Council Works Depot at 208 Lundberg Drive South Murwillumbah (Tweed Shire Council)

Independent Peer Review of Council's Assessment Report

PPSNHTH – 190 (DA 22/0793)

15 September 2023

Figure 2: Fire trail required by DA condition 11C of DA02/1685.27 (Source: SEE p22)

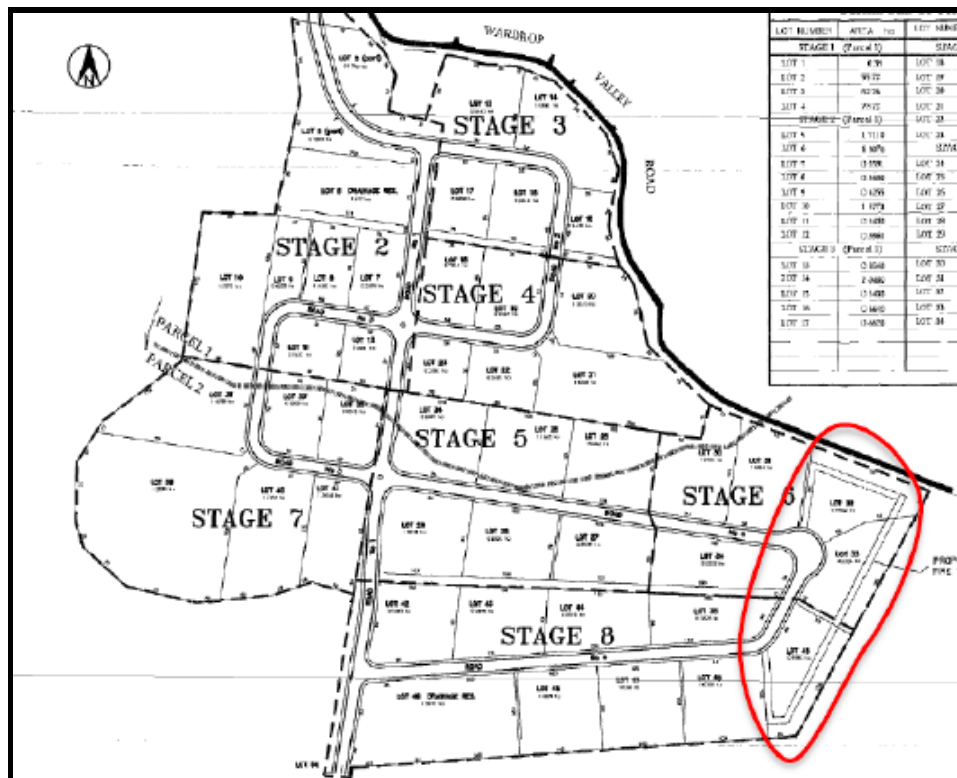
This condition requires a 4 metre wide fire trail along the eastern boundary of the site which is to be registered on the title (**Figure 2**). It would appear that the subject site for the current application comprises Lots 32, 33 and 45 as illustrated in Figure 2.

The Bushfire Report concluded that the proposed access for firefighting is considered sufficient for firefighting intervention without the need for a designated fire trail and therefore condition 11C of DA02/1685.27 is no longer required.

Following review of this recommended condition, it is considered that the condition is required to be more instructive in that it should state that the fire trail is no longer needed and that is the required change to the condition. The instruction that the modification/change is to ensure that the approvals are “*not inconsistent*” is insufficient. It is also unclear from this recommended condition when this modification application should be required to be lodged.

Prior to the issue of a Construction Certificate and pursuant to Section 4.17(1)(b) of the *Environmental Planning and Assessment Act 1979*, the applicant is to modify development consent DA 22/1685.27 in Notice of Determination dated 7 April 2021 as prescribed by Clause 67 of the *Environmental Planning and Assessment Regulation 2021* in the following manner:

*11C. Access to the rear of all lots shall be provided for fire fighting purposes and a perimeter fire trail or access road complying with the publication *Planning for Bushfire Protection* Section 4.2.2 shall be provided on the bushland side of any significant structures located on Lots 5, ~~32, 33 and 45~~. An 88B Restriction is to be placed on the relevant titles to give effect to this condition and is to include provisions for a 20 metre wide asset protection zone where relevant. The draft 88B Instrument is to be submitted to Council for approval prior to release of the subdivision certificate.*
